DEVELOPMENT REVIEW BOARD SUPPLEMENTAL SUBMITTAL

PROJECT NO. 1004000/ PR-2018-0001
Application No. SI-2018-00031

SUBMITTAL DESCRIPTION: Updated Plan Set with comments

**RE: PRIMROSE DRB PROJECT NUMBER: 2018-001183 (1004000)
SITE DEVELOPMENT PLAN FOR BUILDING PERMIT**

PRIMROSE SCHOOL OF NW ALBUQUERQUE
CONSTRUCTION DETAILS

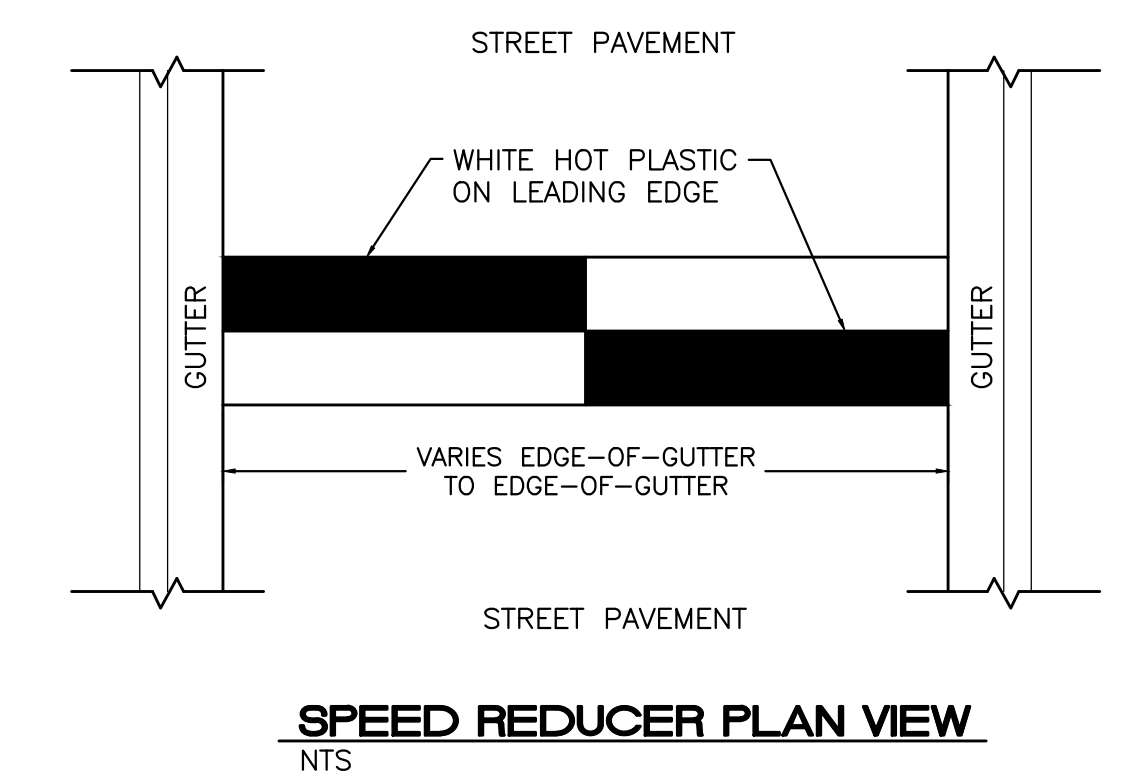
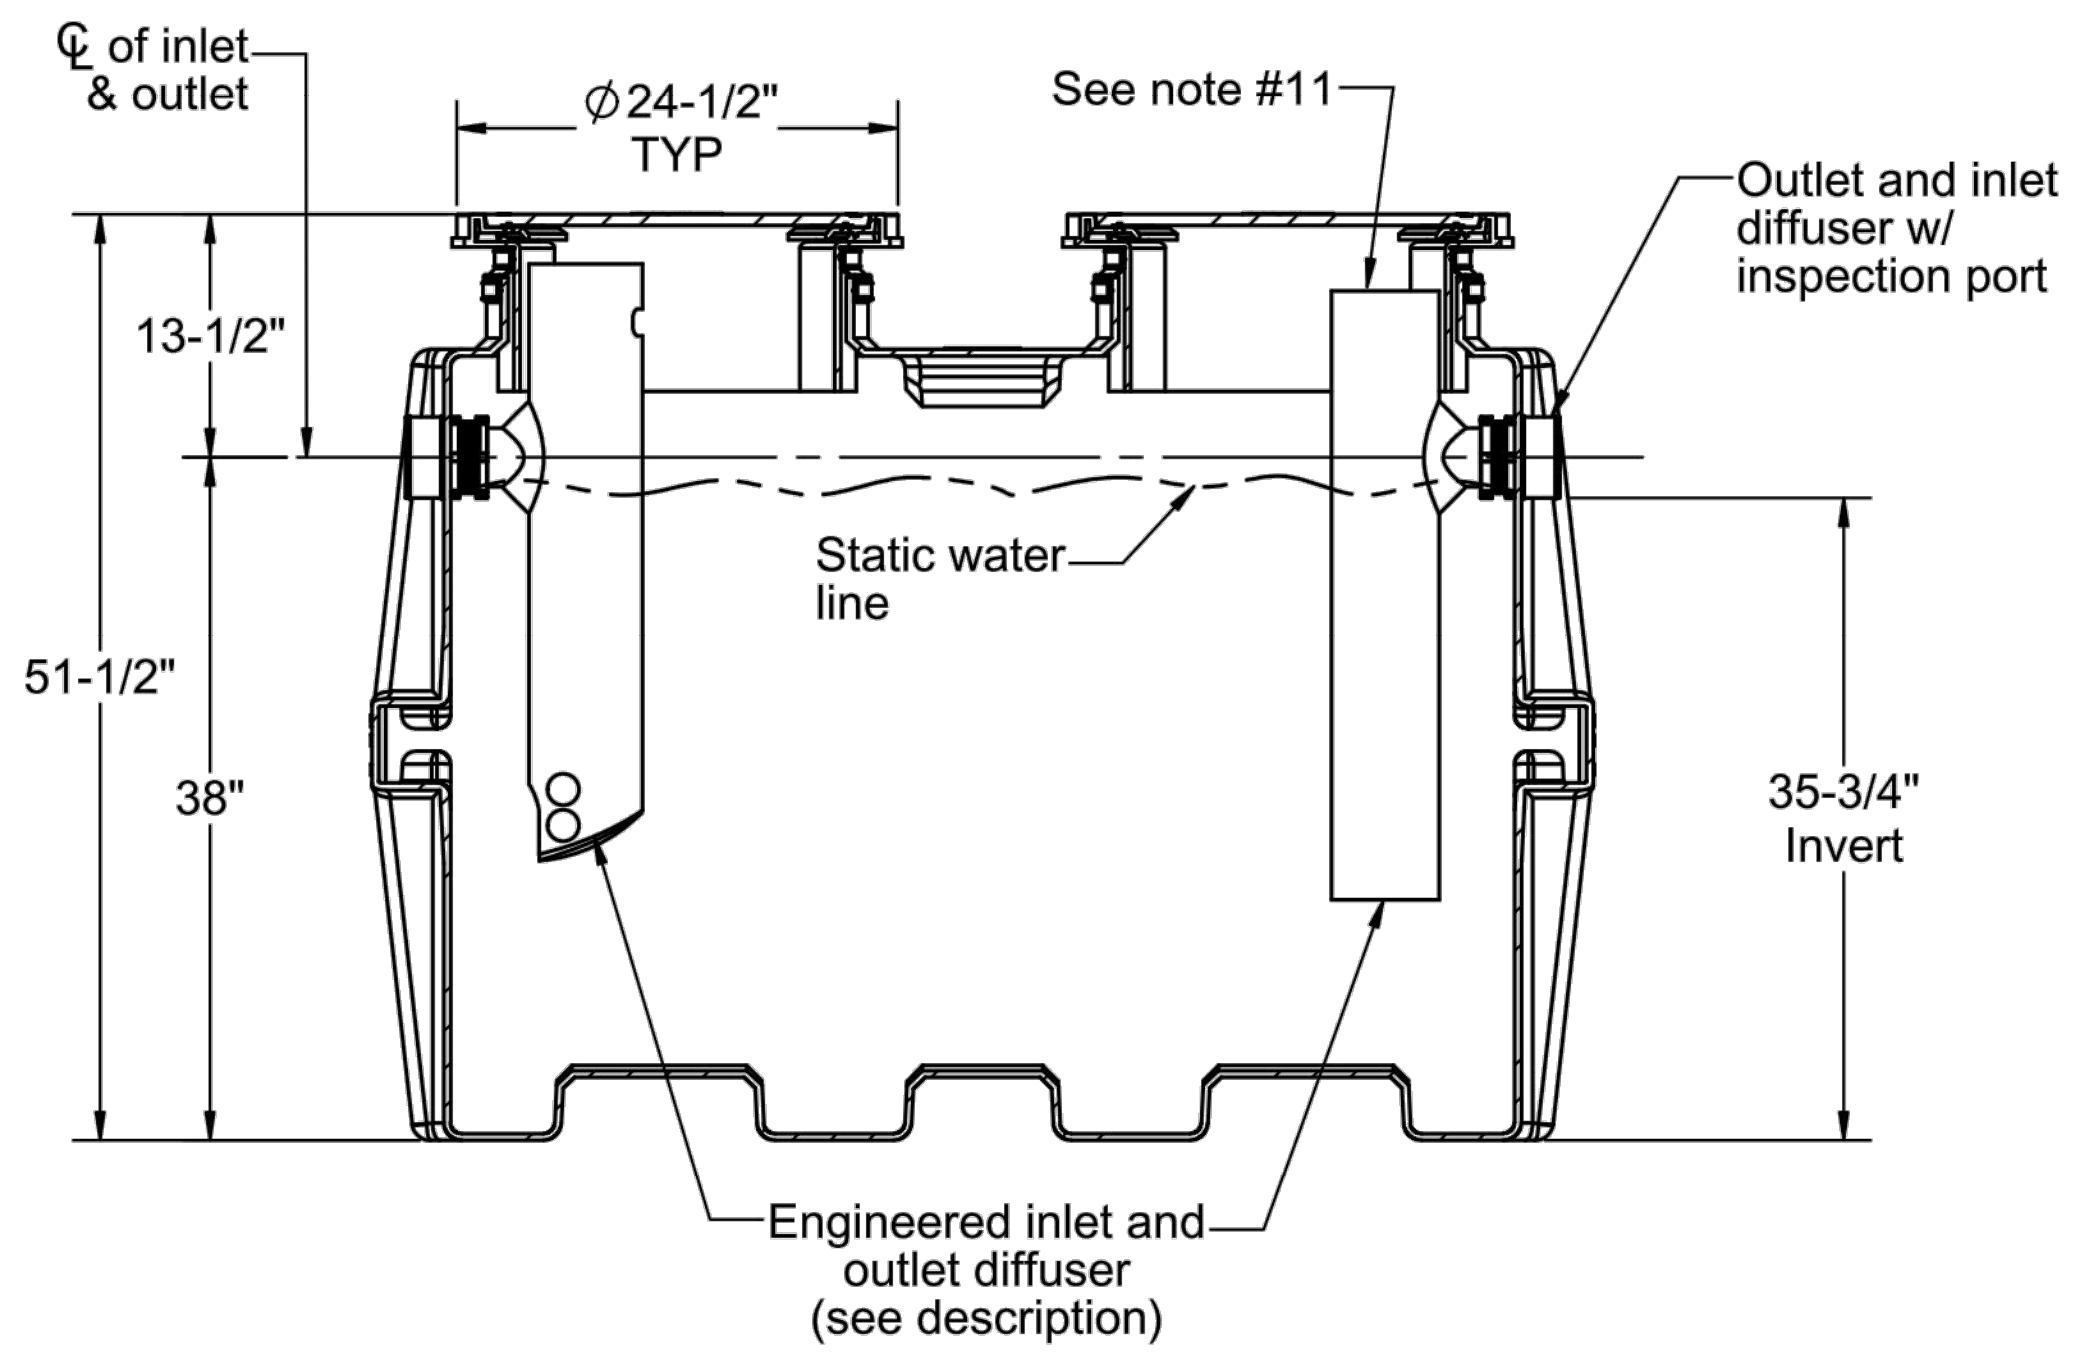
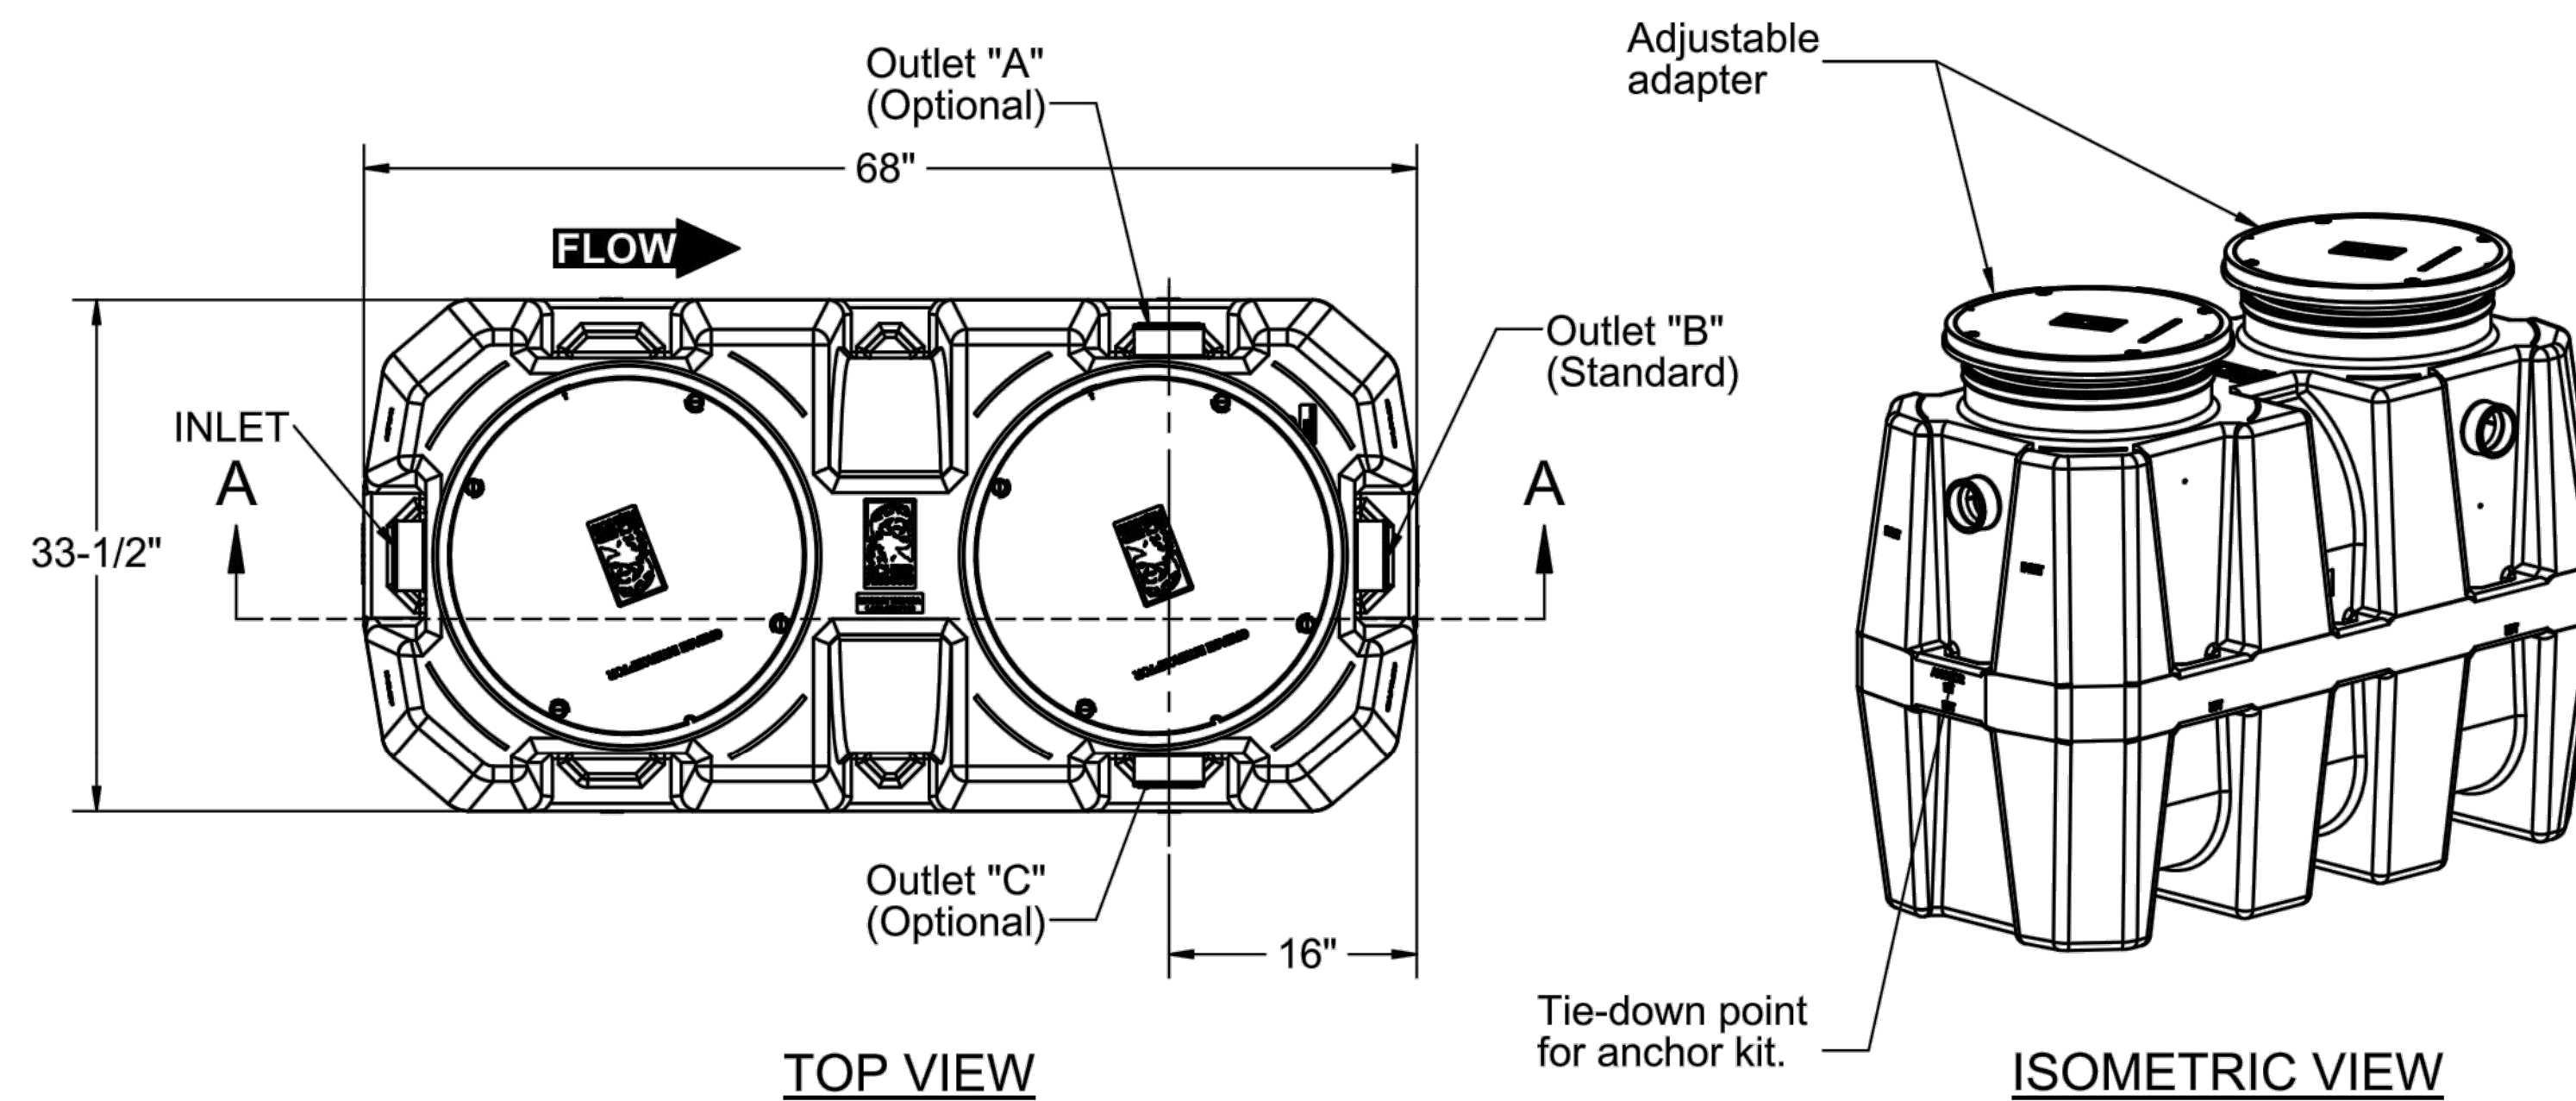
3. Provide detail for "speed reducer".
The speed reducer detail is found on Sheet 6.
4. Verify with NMDOT whether sidewalk along Paseo del Norte is required.
We have contacted NMDOT and they are reviewing if they need the sidewalk or not. We should receive a response back from them prior to the DRB Hearing. We have left it on the plans for now and will update the sheets if it is not required.
